TOWN OF NEW HARTFORD PLANNING BOARD MINUTES

APRIL 8, 2019

***Greenstate Properties for a Preliminary/Final Site Plan Review** of a proposed 8,000 sf office building at New Hartford Office Park - Woods Highway. Tax Map #328.000-3-7.1. Zoning: C1 General Business. Messrs. Matt Napierala and Connor Colbert of Napierala Consulting; Mr. Larry Adler of New Hartford Office Group, appeared before the Board.

From: Brian Madigan, RLA, CPESC <BMADIGAN@GYMODPC.COM>
Sent: Thursday, April 11, 2019 11:58 AM
To: Shaw, Dory
Subject: Greenstate properties.

328.000-3-7.1 Project Site General Area

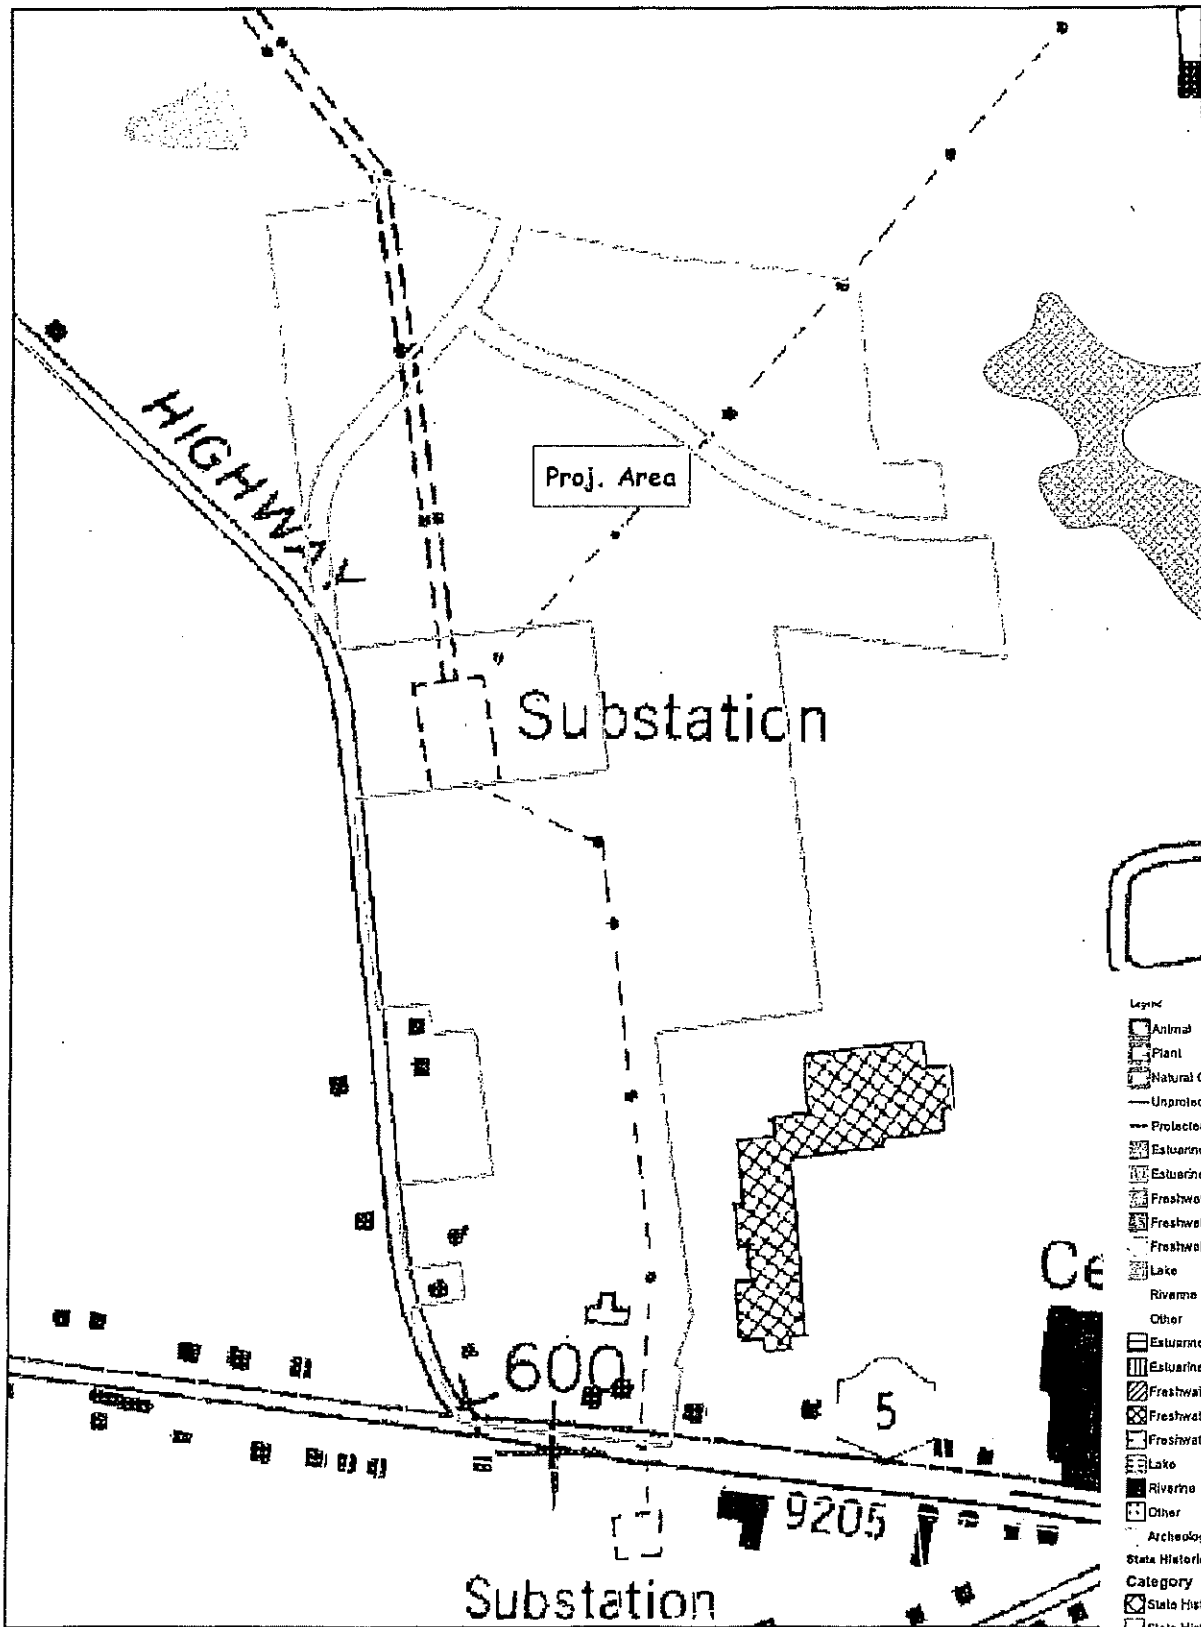
Brian,
Attached is the map we discussed on the phone.

Based on your description of the project (office space, no manufacturing, public water and sewer, located within an existing business park) it appears that the only jurisdiction we would have is the General Permit for Stormwater Discharges from Construction Activity. As you are aware the SWPPP's (Stormwater Pollution Prevention Plan) are authorized by our Albany Office upon submission of the NOI (Notice of Intent). In this case you will also be required to submit the MS4 Stormwater Pollution Prevention Plan (SWPPP) Acceptance Form with the NOI.
